Integrus Architecture, P.S.
117 S Main Street
Seattle, WA 98104
(206) 628-3137

The additions, clarifications and corrections contained herein shall be made to the Project Manual, Drawings and Schedules for the above referenced project, and shall be included in the scope of work and proposal to be submitted.

Sartori Elementary School

REF. SHEET C2.1
DWG. #: **ADC-014**
JOB #: 21607.00
DRAWN BY: FAK
DATE: 03/17/17
REF. DOC.: ADDENDUM #1

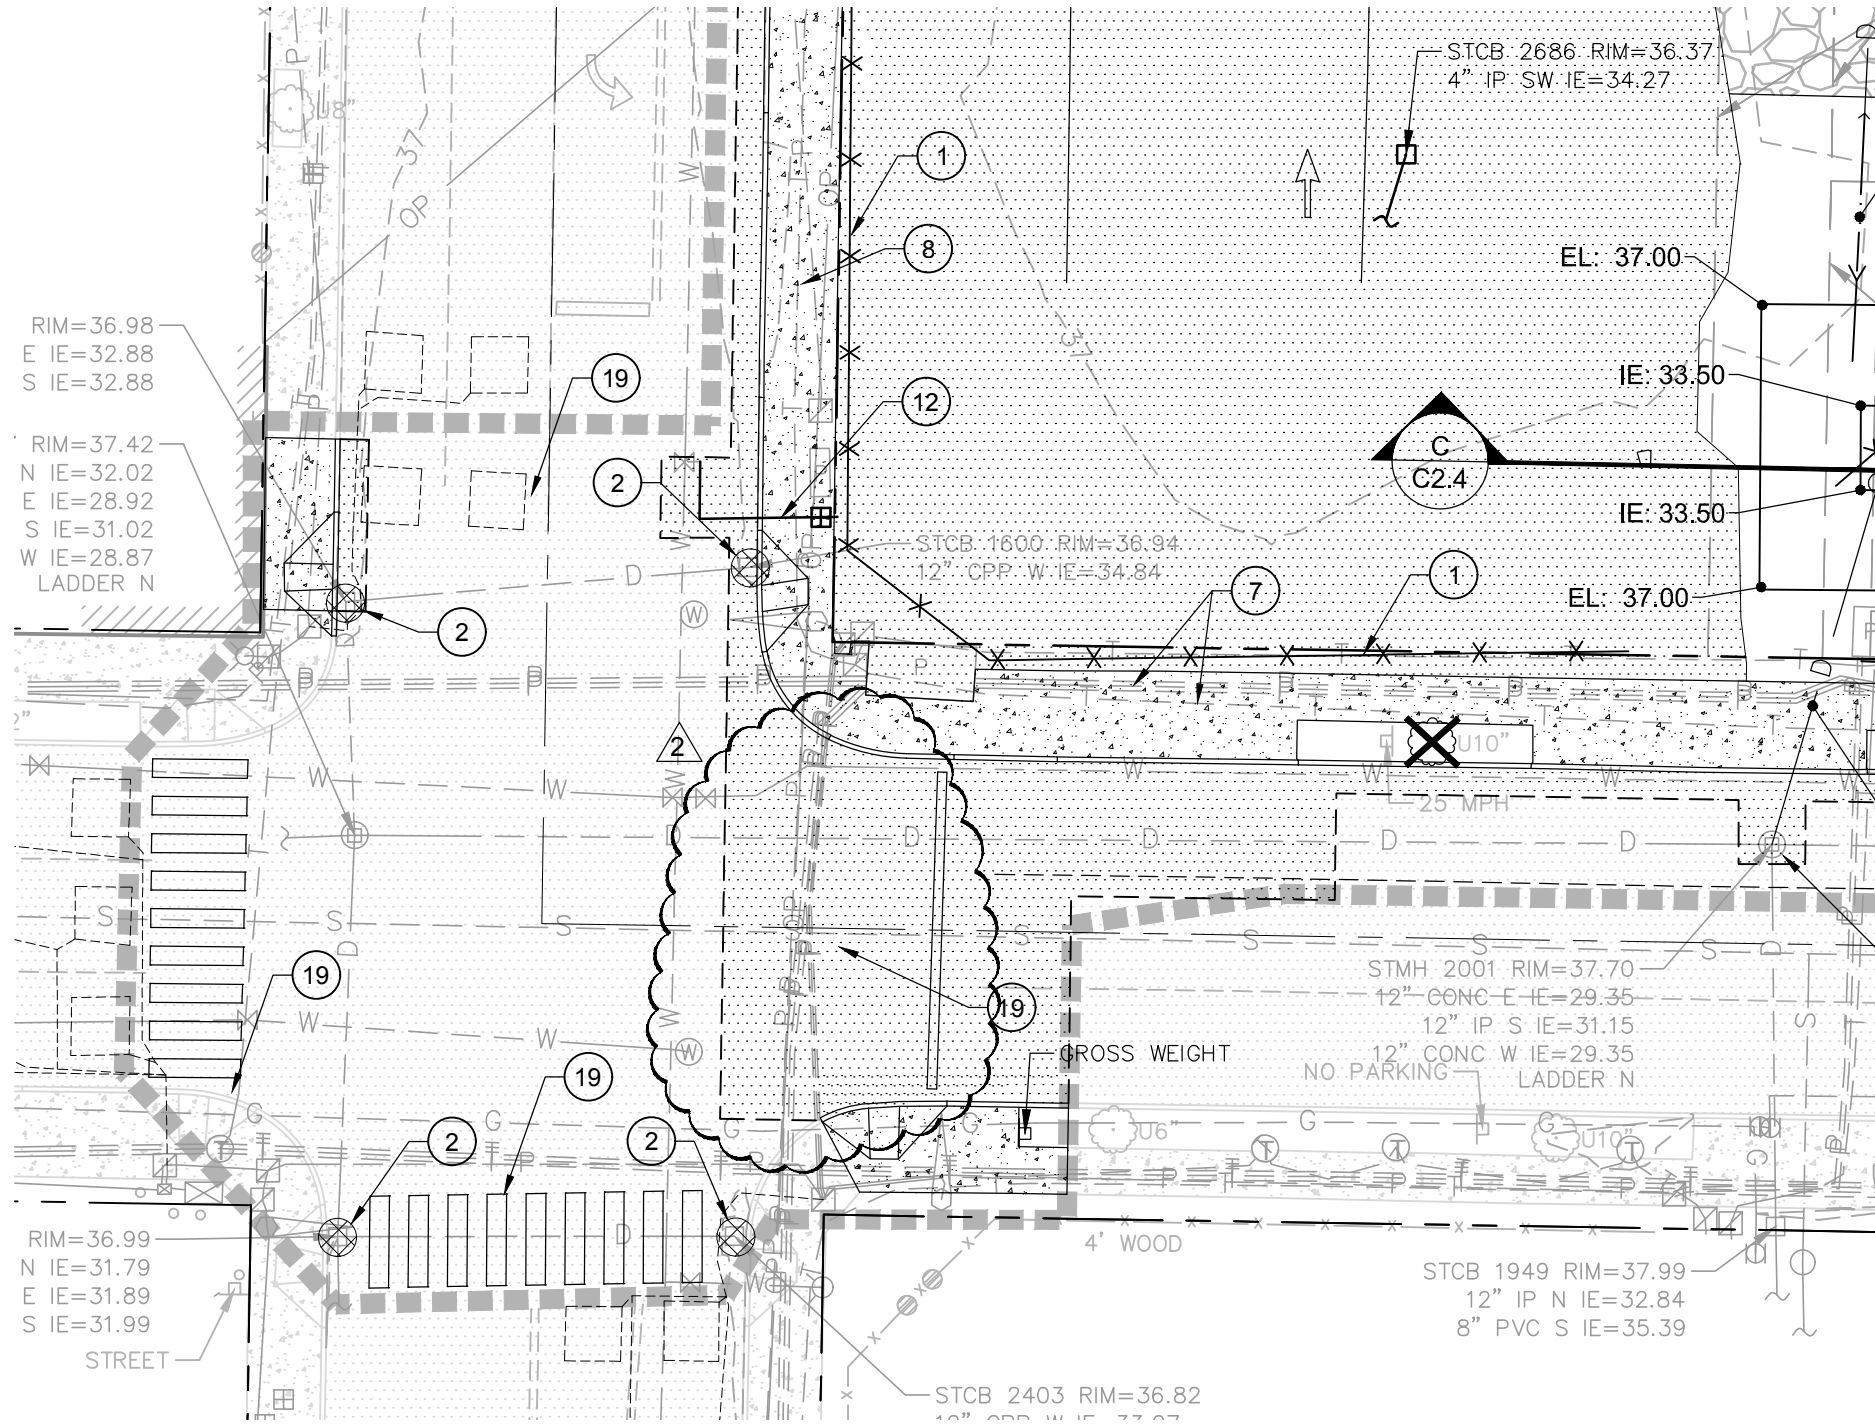
ADD #03 **Revise** pavement demolition limits as indicated by ADC 014.

Add Keynote No. 18 for traffic loop demolition as indicated by ADC 014.

REF. SHEET C2.2

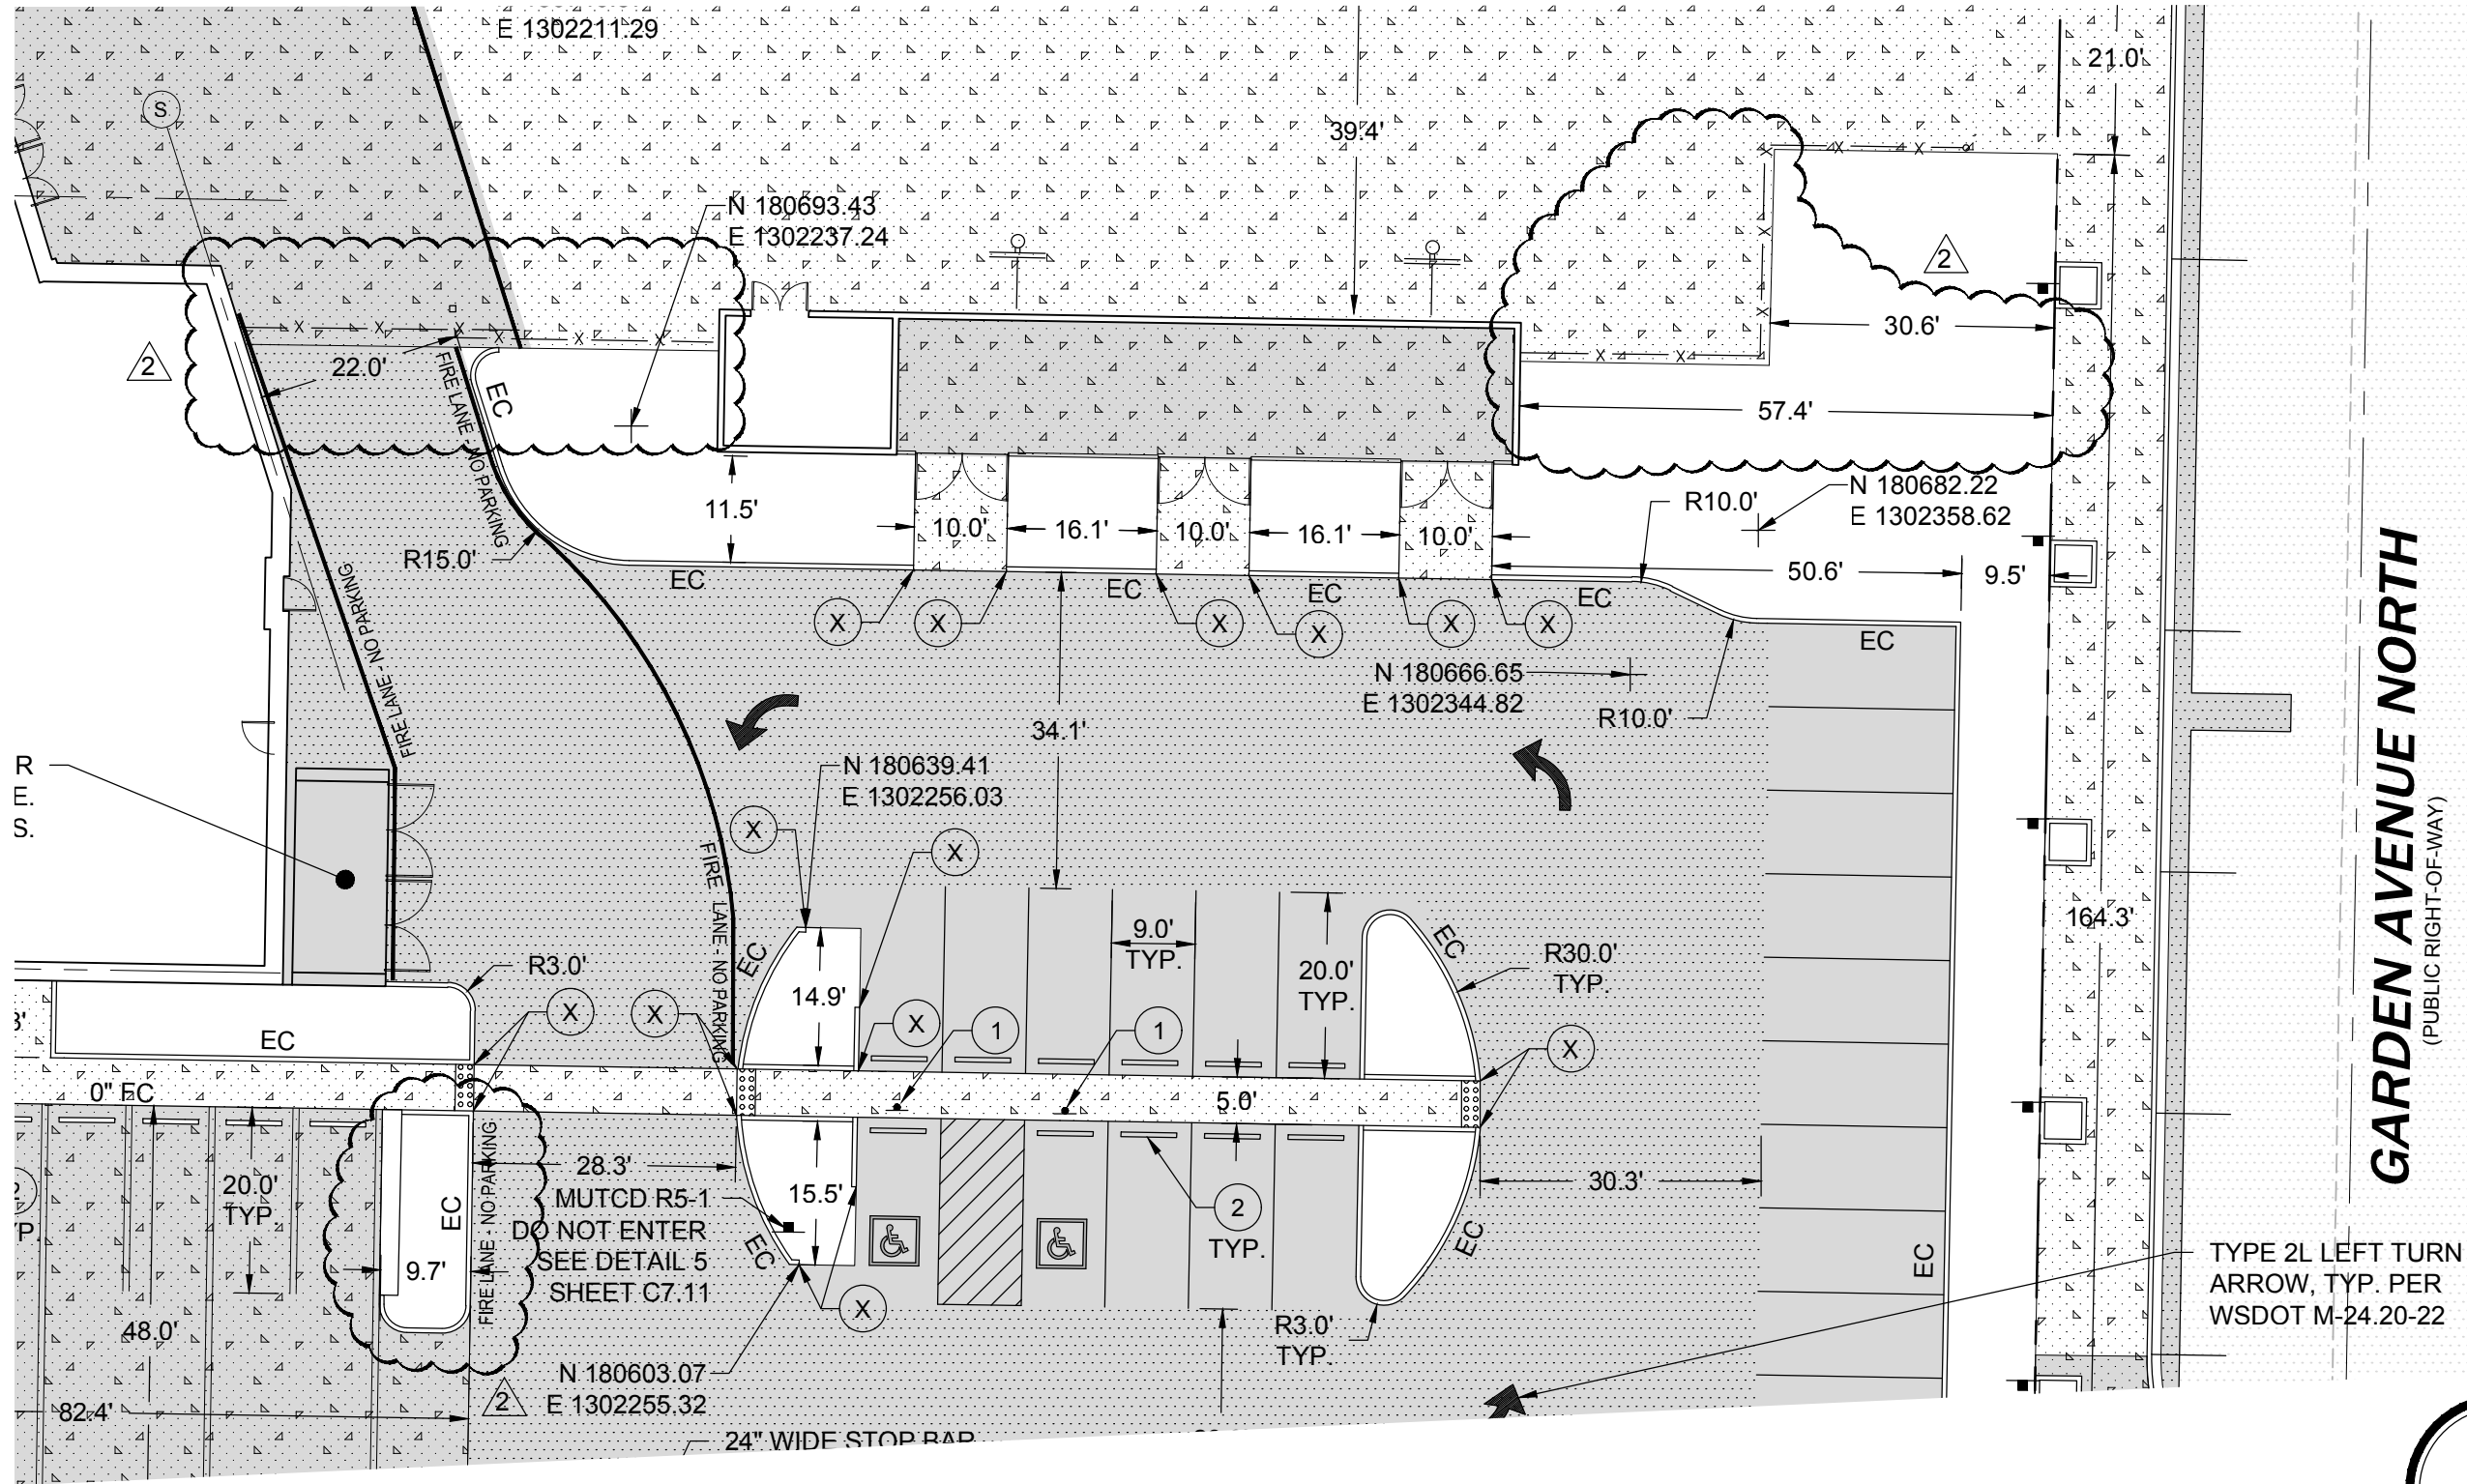
ADD #03 **Revise** pavement demolition limits as indicated by ADC 015.

DWG. # **ADC-017**
JOB # 21607.00
DRAWN BY: FAK
DATE: 03/17/17
REF. DOC.: ADDENDUM #1

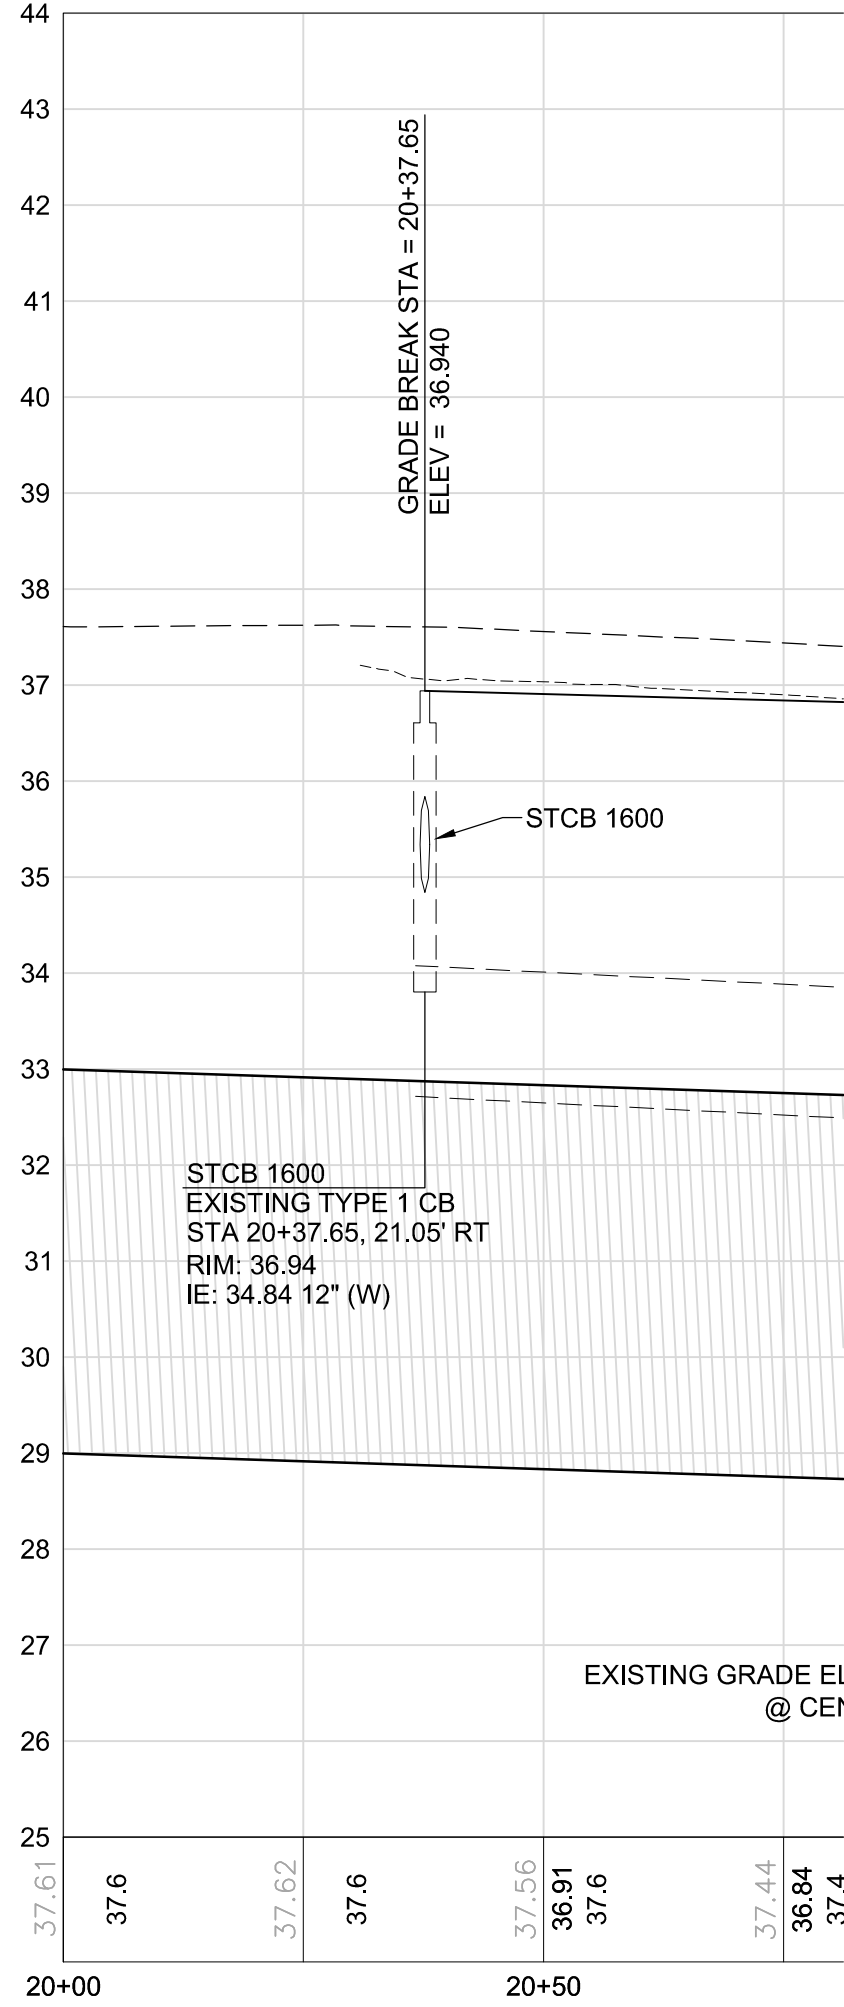
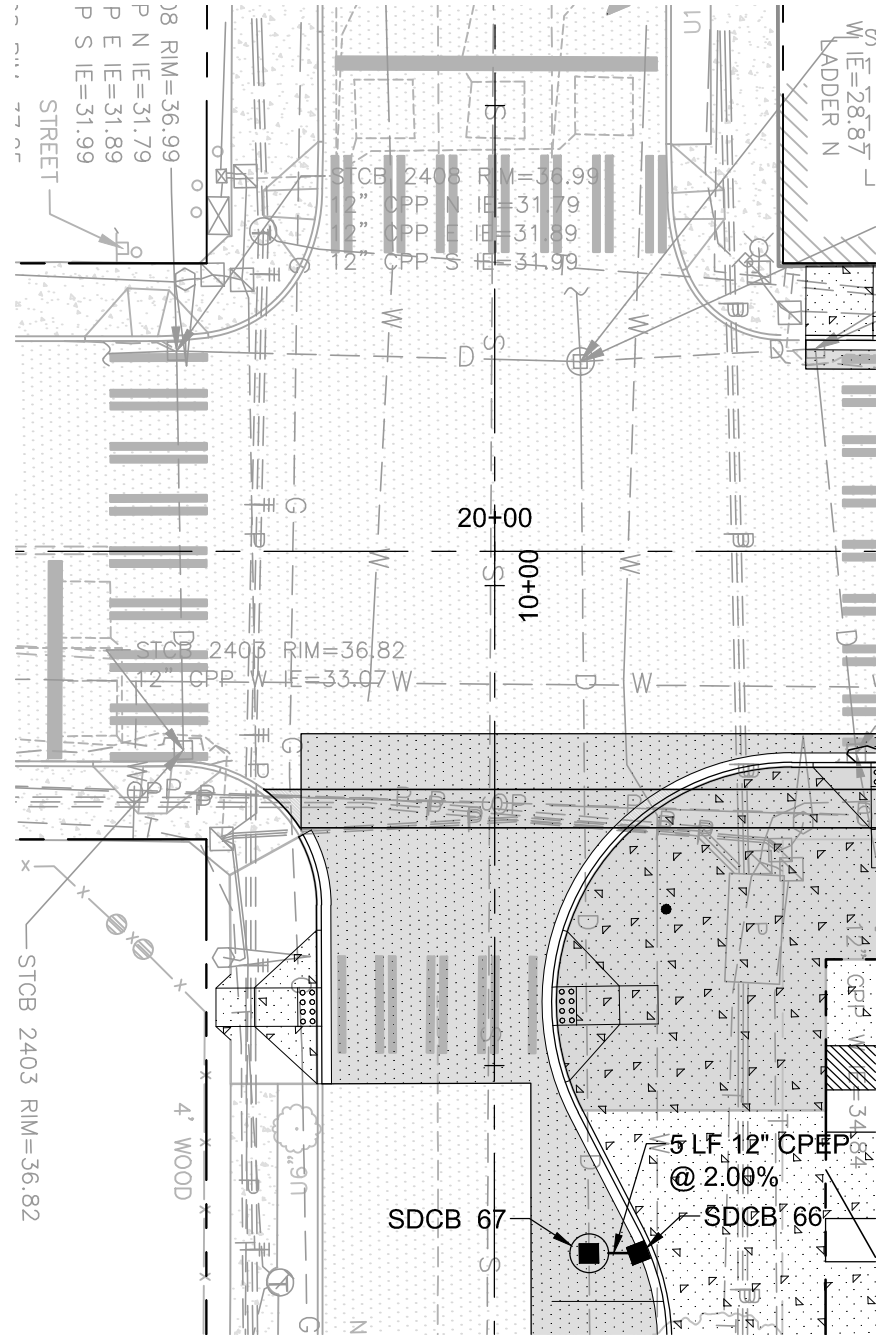
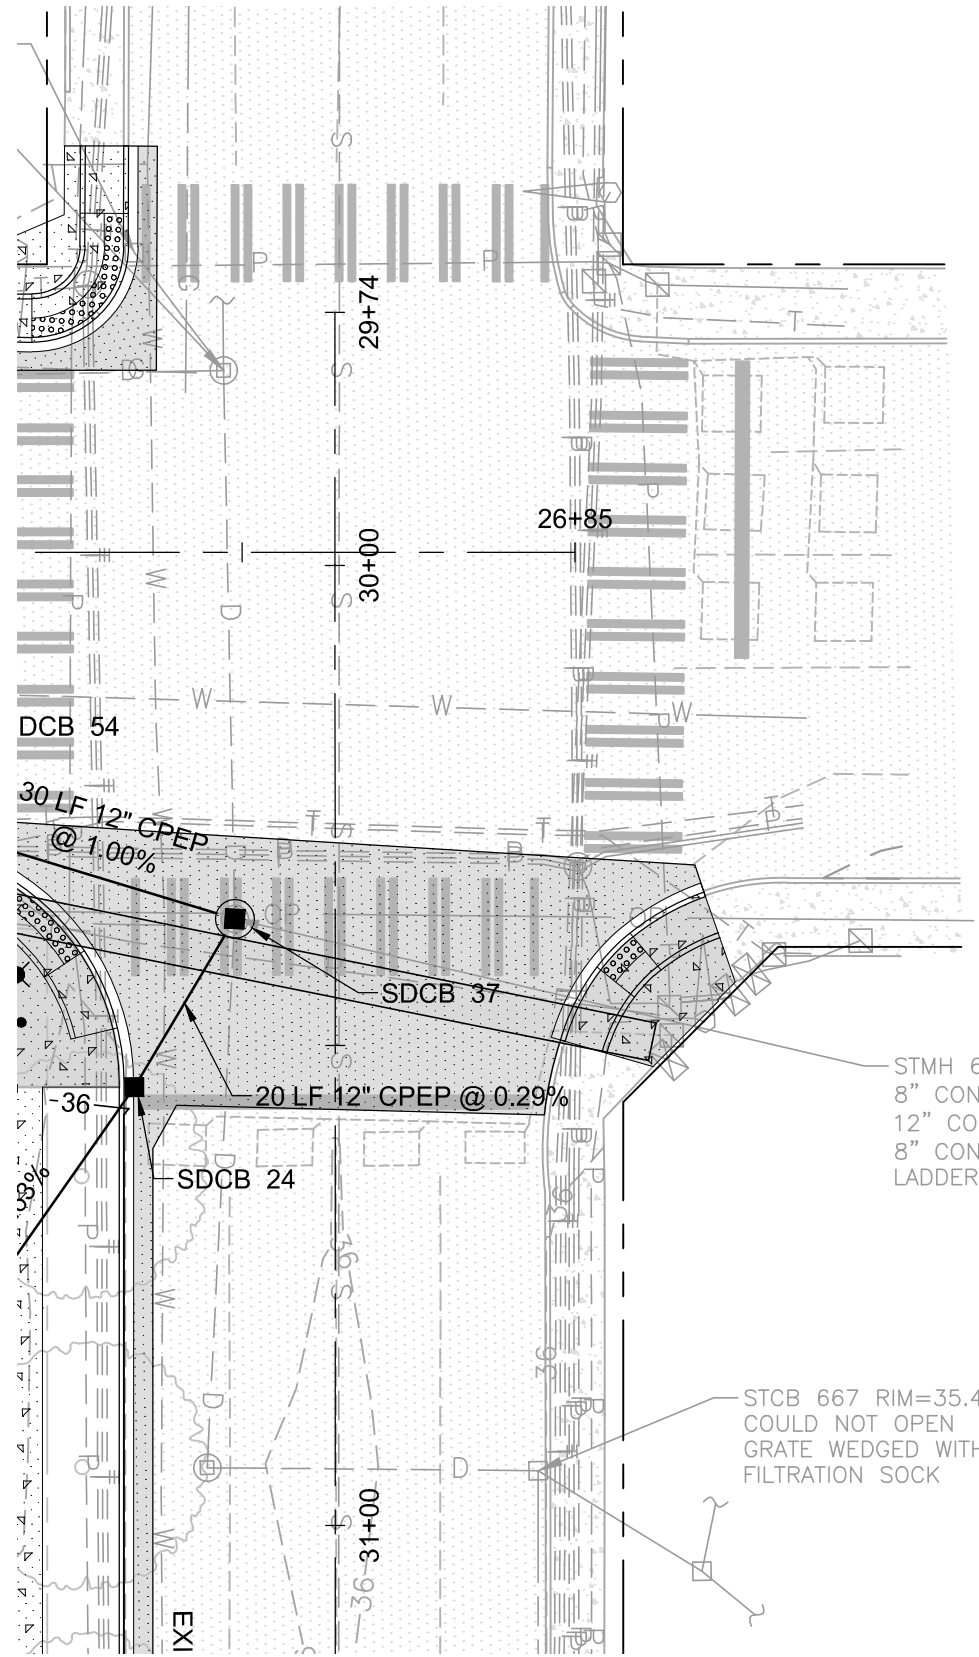
- Item #C15 C5.2 – SOUTH PAVING AND HORIZONTAL CONTROL PLAN
ADD #03 **Revise** paving limits, curb limits and dimensions as indicated by ADC 017.
 Revise Keynote No. 10 to read as follows “Accessible parking sign per detail 9 on Sheet C7.8.”
